[Docket No. 96-CE-09-AD]

Airworthiness Directives; The New Piper Aircraft, Inc. PA24, PA28R, PA30, PA32R, PA34, and PA39 Series Airplanes

ACTION: Notice of proposed rulemaking (NPRM).

The New Piper Aircraft, Inc.: Docket No. 96-CE-09-AD; Supersedes AD 95-20-07, Amendment 39-9386.

**Figure 1**

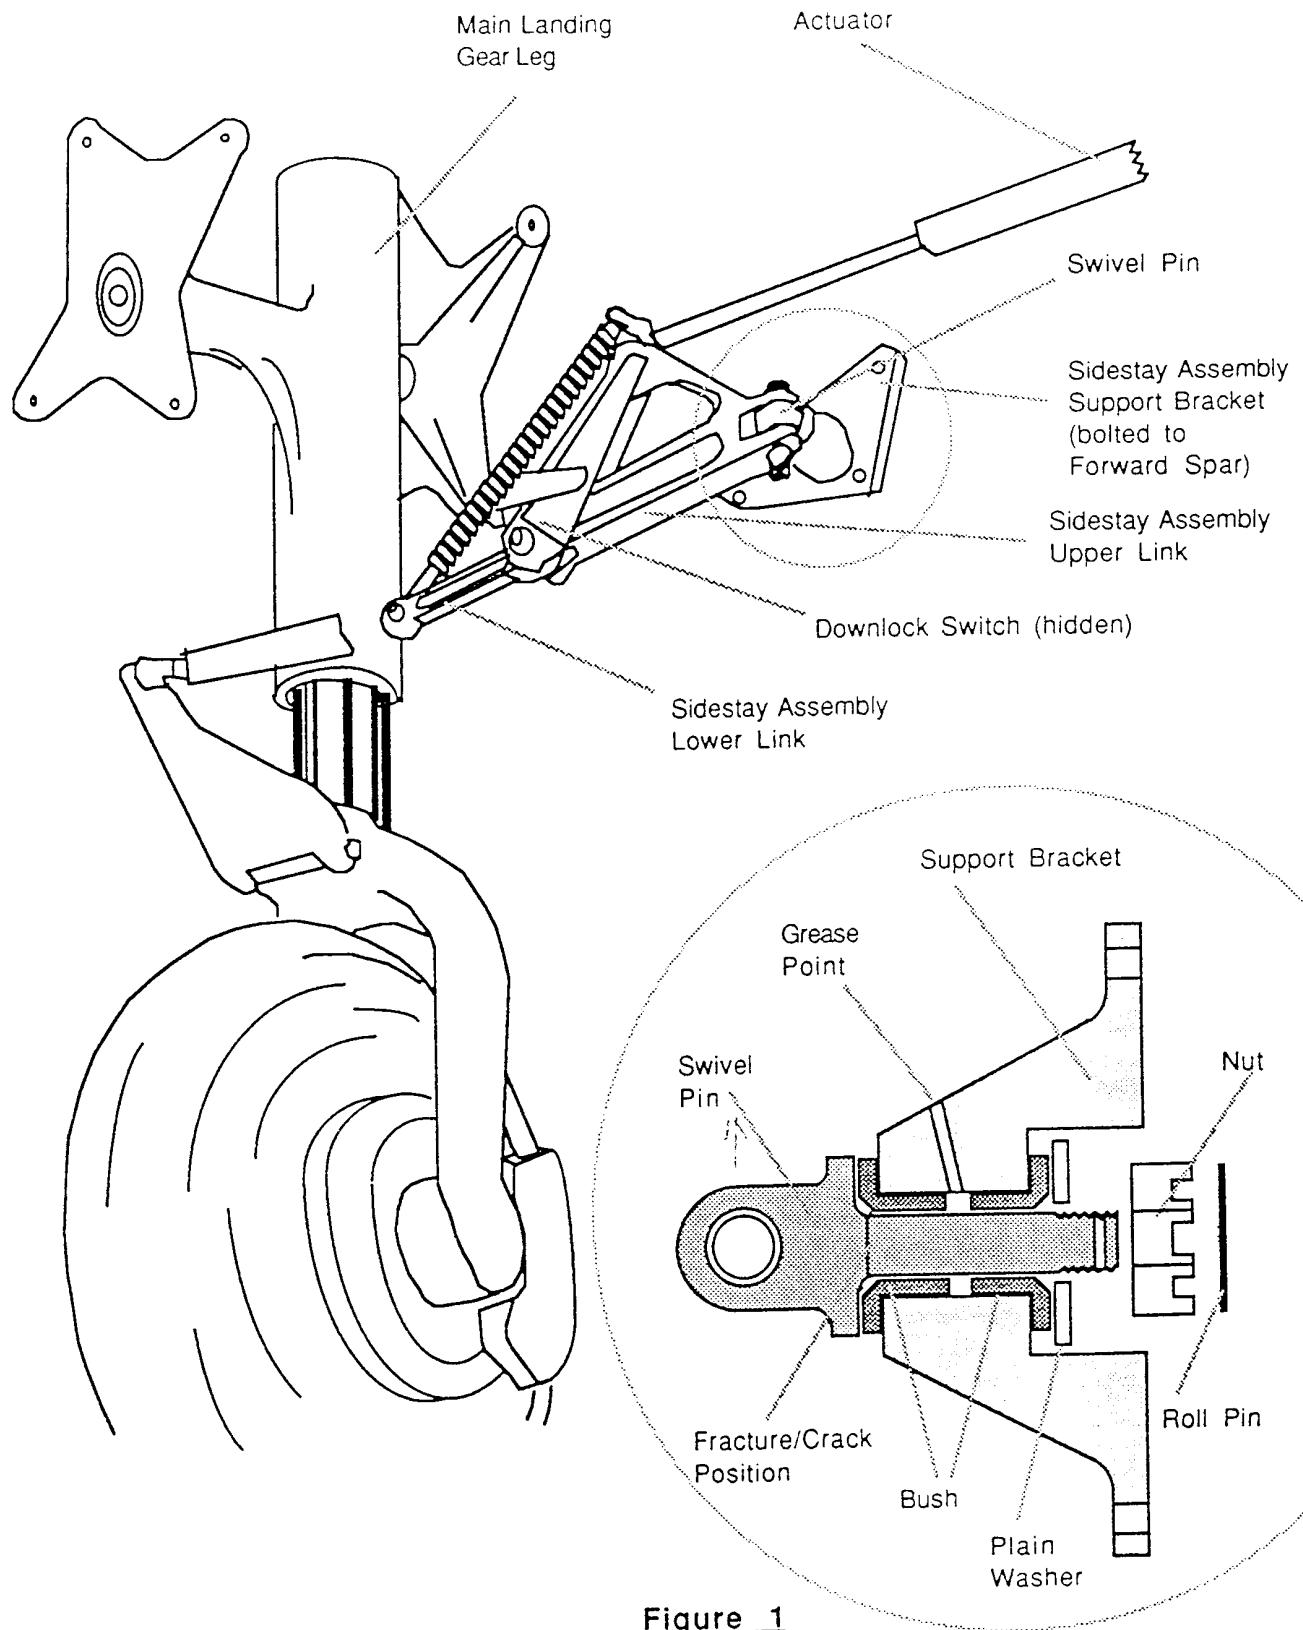
(a) Remove both the left and right main gear side brace studs from the airplane in accordance with the instructions contained in the Landing Gear section of the maintenance manual, and inspect each main gear side brace stud for cracks, using Type I (fluorescent) liquid penetrant or magnetic particle inspection methods. Figure 1 of this

AD depicts the area of the sidebrace stud shank where the sidebrace stud is to be inspected.

(1) For any main gear side brace stud found cracked, prior to further flight, replace the cracked stud with an FAA-approved serviceable part (part numbers referenced in the table in paragraph (b) of this AD or FAA-approved equivalent) in accordance with the instructions contained in the Landing Gear section of the applicable maintenance manual, and accomplish one of the following, as applicable:
